Addendum #4

Fire Truck Building at Woodville Training Site (WTS), T2 R9 TWP, Maine Project No. 23TC21-503-D, Bid #23-001

9 August 2022

SHEET ID:
A-303
 SHEET: 19 OF 37

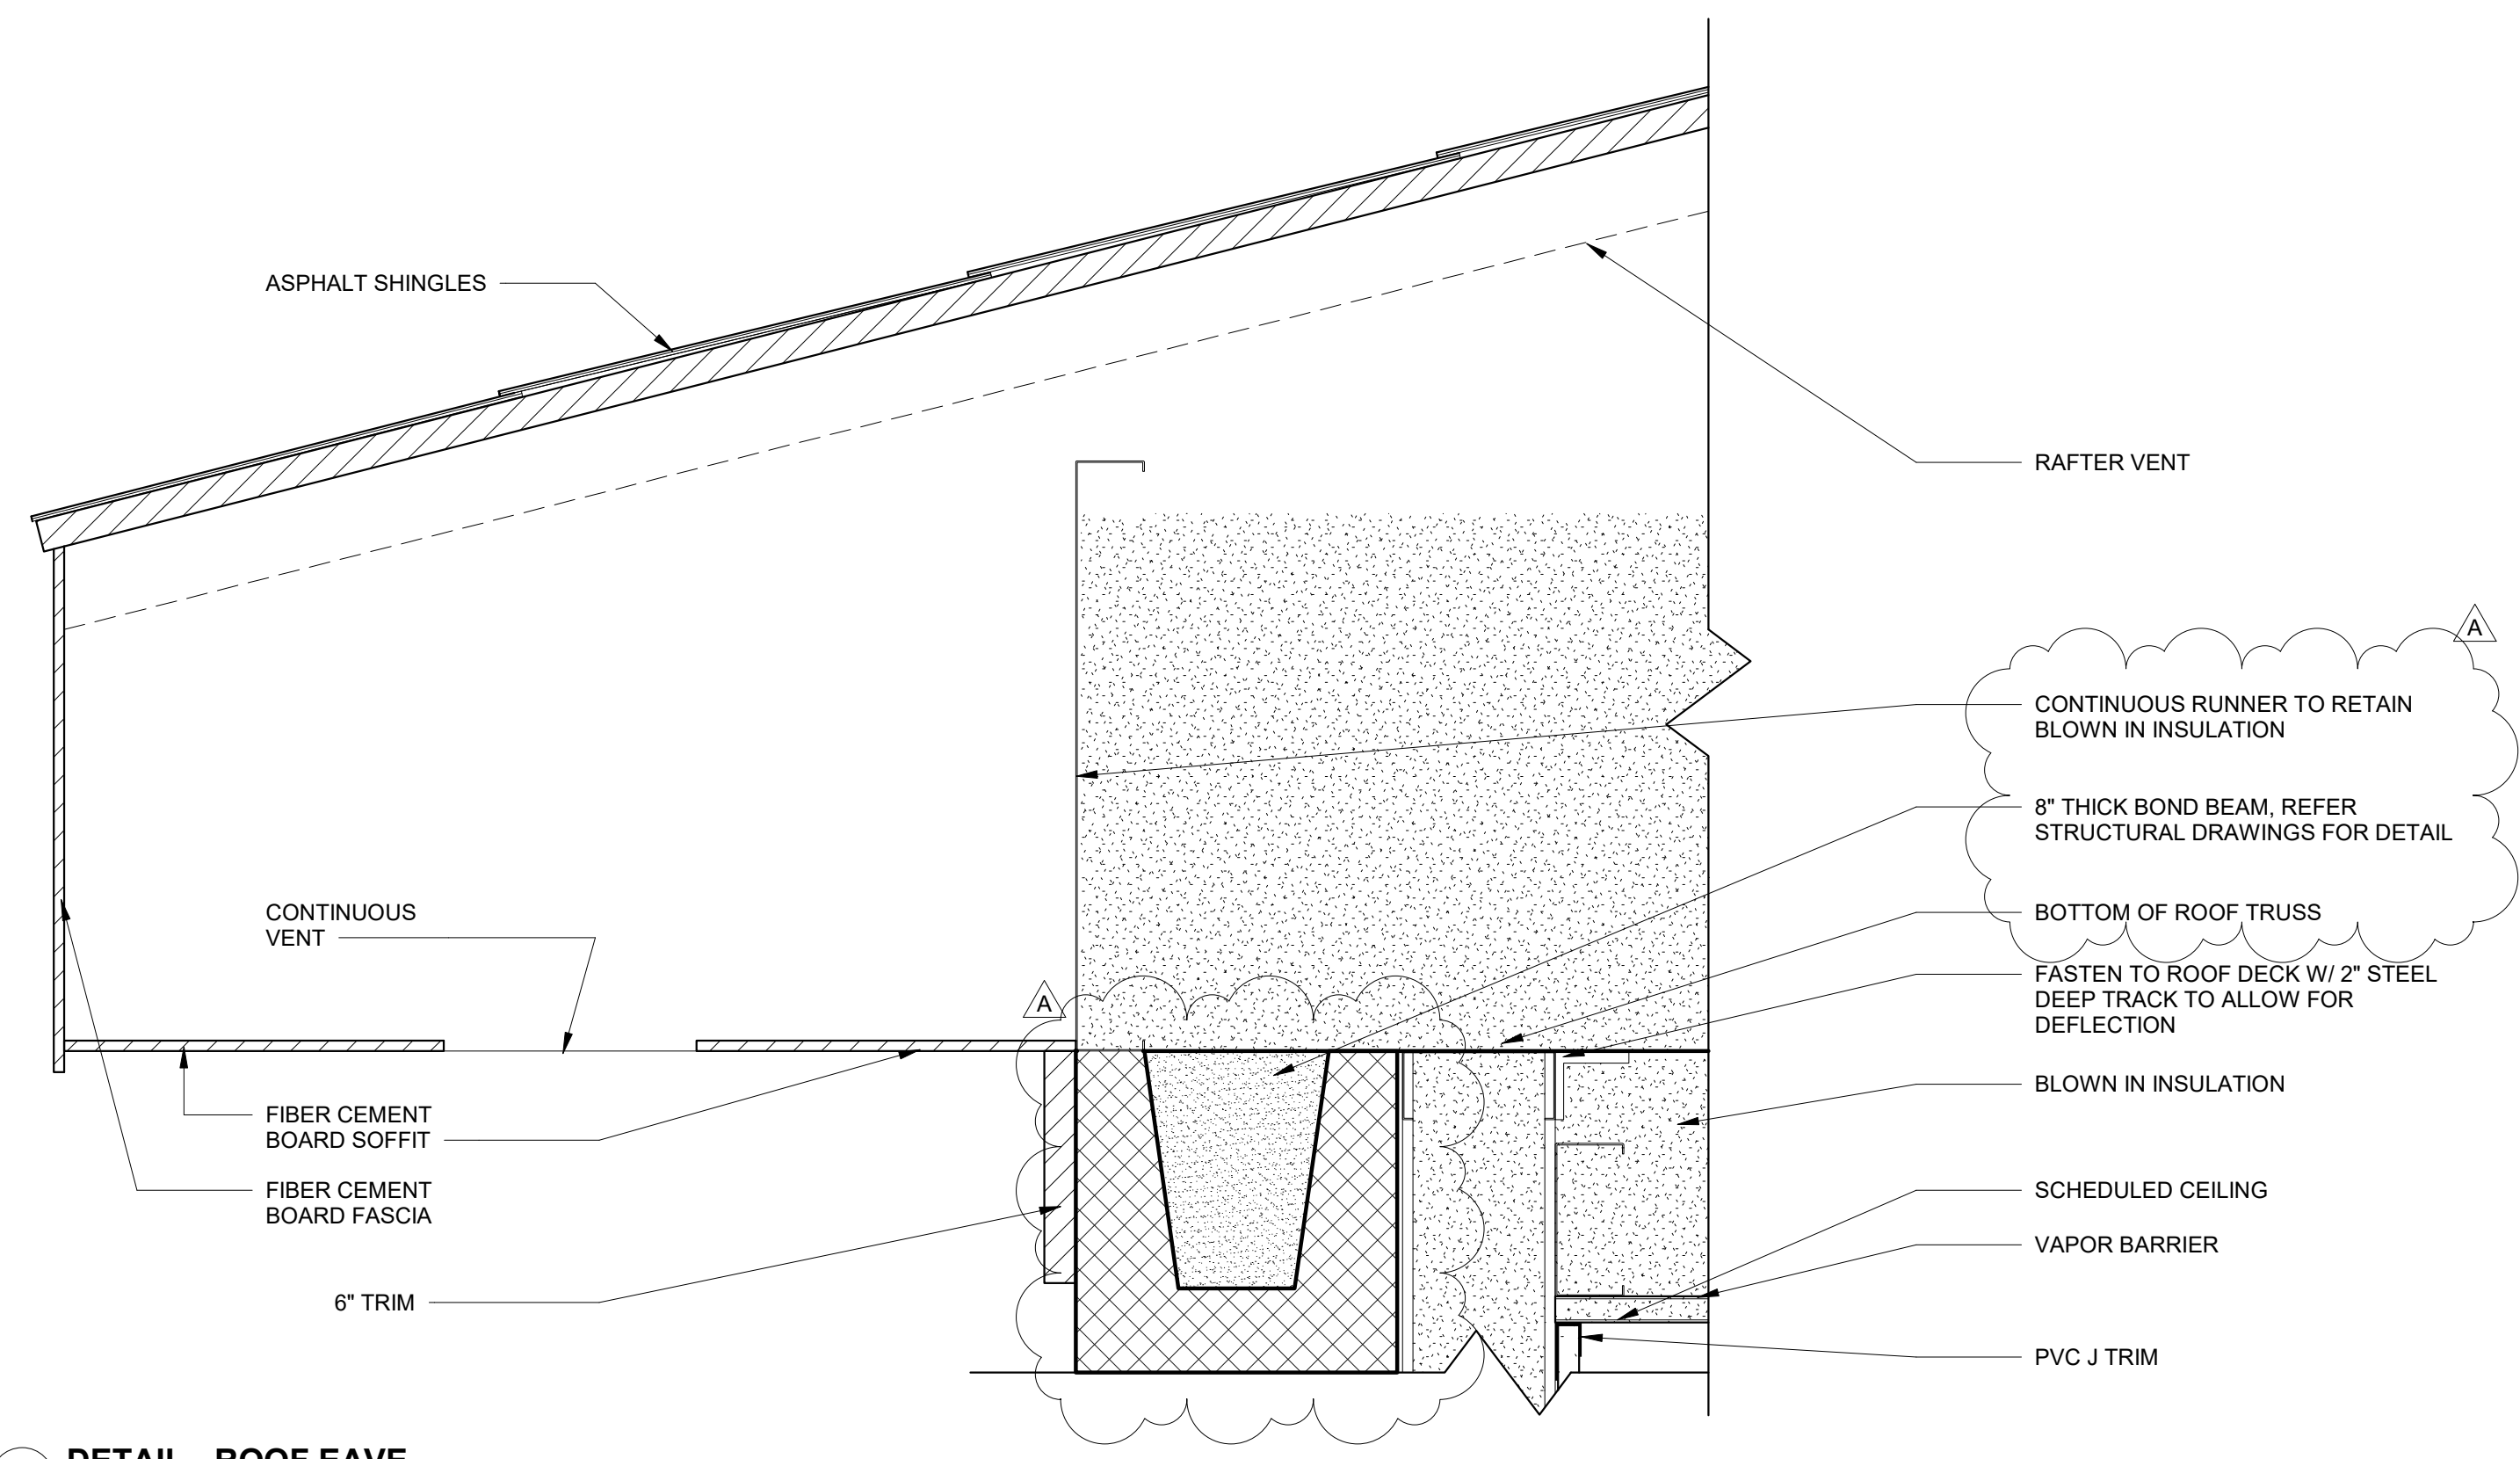
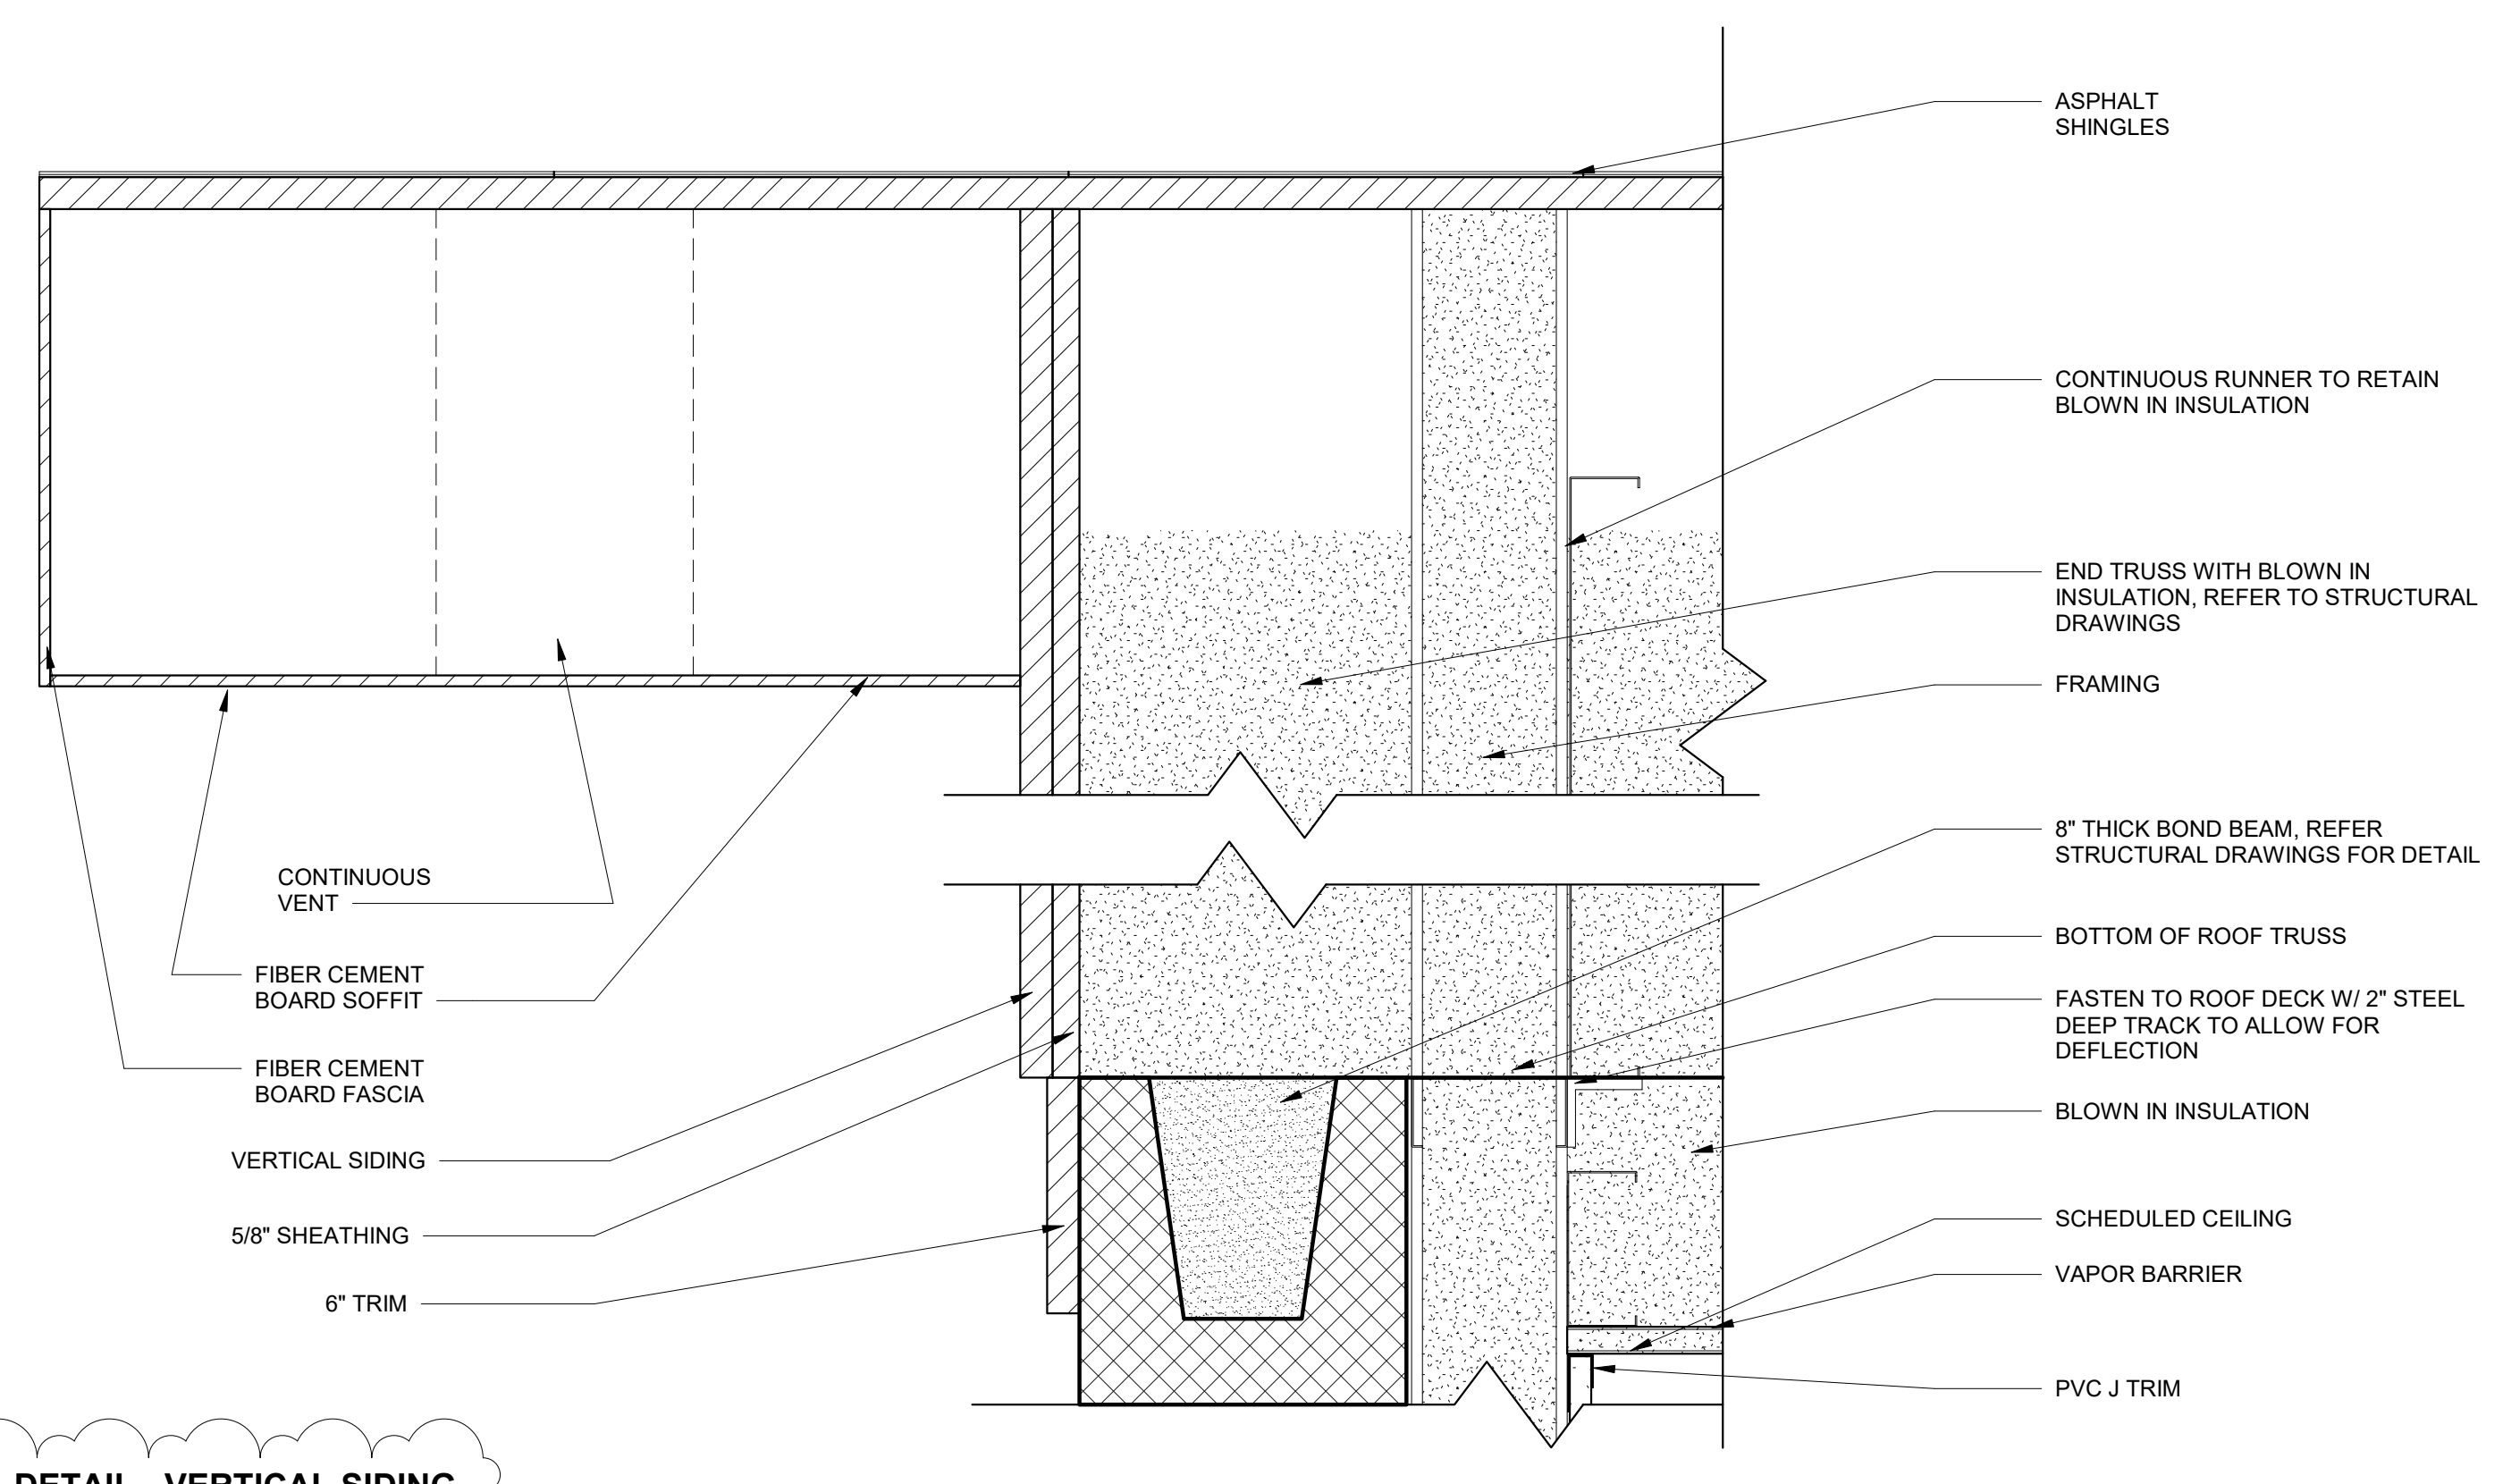
- Exterior wall details show “attached runner to floor at 16” oc and within 1” of ends. Can you please provide more detail on what exactly you are looking for here? Is this steel track?

- To be fabricated, Structural to add handrail detail and drawings, top and middle rail and kickplate.
- Roof Eave detail shows Fiber cement board soffit. James Hardie makes a soffit panel. Is this what you are looking for or are you looking for cement board panels with separate continuous vent?

- It is a steel track, can use 2”
- There does not appear to be any details for the gables for framing/sheathing/siding/etc. Can you please provide information regarding the construction of the gables above the cmu wall? I know the finish is specified but I don’t see any additional information here for framing on top of CMU wall, etc.
